MODIFICATION No.: 23143K2664 (Partial)

TITLE: AIR CONDITIONING - AIR COOLING SYSTEM - INTRODUCE AIR CYCLE MACHINE

PN 757A0000-09

SERVICE BULLETIN No.: A320-21-1064

Location of Air Cycle Machine Figure 1

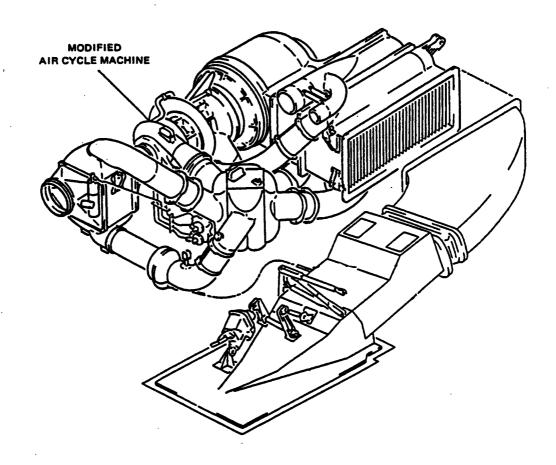
Refer to Figure 1

- (1) Replacement of anti ice valve.
 - (a) Remove the anti-icing valve (Ref. AMM 21-61-41, P. Block 401) for modification as per LIEBHERR ABG SEMCA Service Bulletin No. 748A-21-02.

(b) Install the modified air cycle machine (Ref. AMM 21-52-21, P. Block 401)
